CUT PATTERN	
BACK FRAME NO.	
BASE FRAME NO.	
WOOD PATTERN

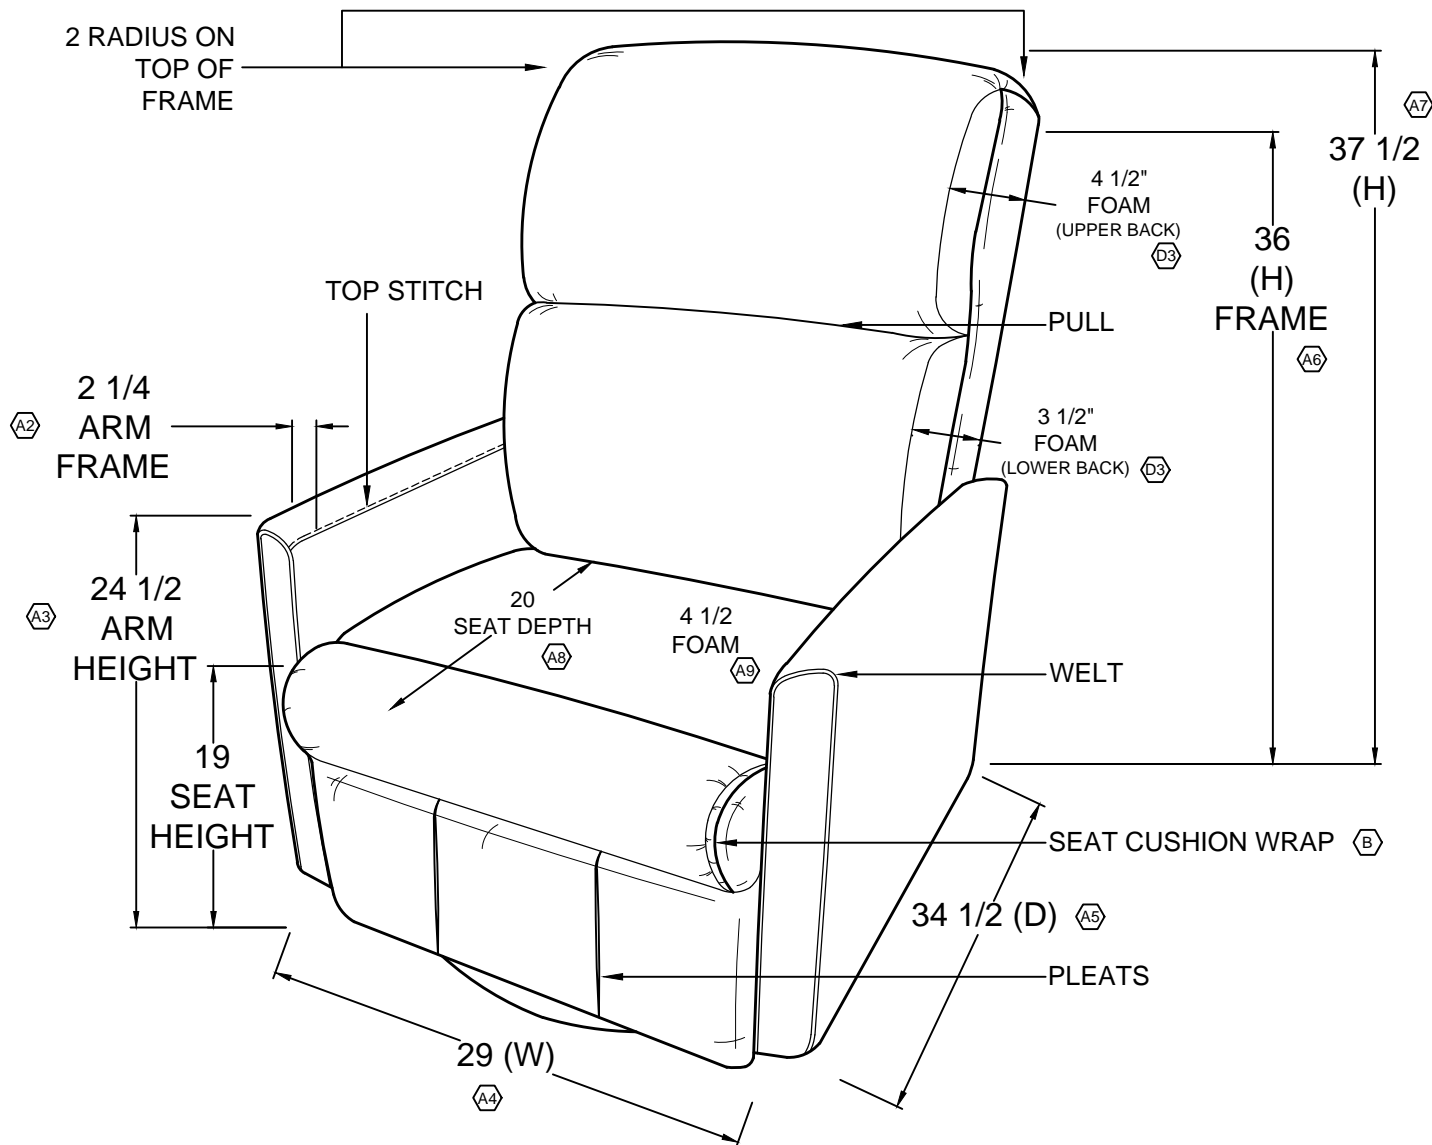
- CONNECT SEAT WRAP TO FOOTREST.
- ADD BLACK DECKING SKIRT INSIDE FOOTREST.

JA	E	ADD NOTES TO CONNECT WRAP TO FOOTREST PANEL AND ADD BLACK DECKING SKIRT TO INSIDE FOOTREST. (REF. ECO #058-2019)	02.24.2020
JA	D	[1] ADD SPRING CLIPS TO SEAT SPRINGS. [2] ADD 8x24 602 SPRINGS x4. [3] ADD 4-1/2\" FOAM TO UPPER BACK & 3-1/2\" FOAM TO LOWER BACK. (REF. ECO #029-2019). [4] MECHANISM LEG A410812333S 23\" WIDE MECH W/SWIVEL 4108-2. (REF. ECO #058-2019)	06.10.19
JA	C	PER RL, ADD SEAM TO SEAT FOR CUSHION WRAP.	04.09.19
JA	B	ADD SEAT CUSHION WRAP. (REF. ECO# 031-2019)	03.29.19
JA	A	PRODUCTION UPDATE: [1] ADD ARM FRAME DETAIL. [2] CHANGE ARM FRAME WIDTH TO 2-1/4\" WAS 2\". [3] CHANGE ARM HEIGHT TO 24-1/2\" WAS 27\". [4] CHANGE WIDTH TO 29\" WAS 35-1/2\". [5] CHANGE DEPTH TO 34-1/2\" WAS 36-1/2\". [6] CHANGE FRAME HEIGHT TO 36\" WAS 38\". [7] CHANGE O.A. HEIGHT TO 37-1/2\" WAS 40-1/2\". [8] ADD 20\" SEAT DEPTH. [9] ADD 4-1/2\" SEAT FOAM.	01.28.19
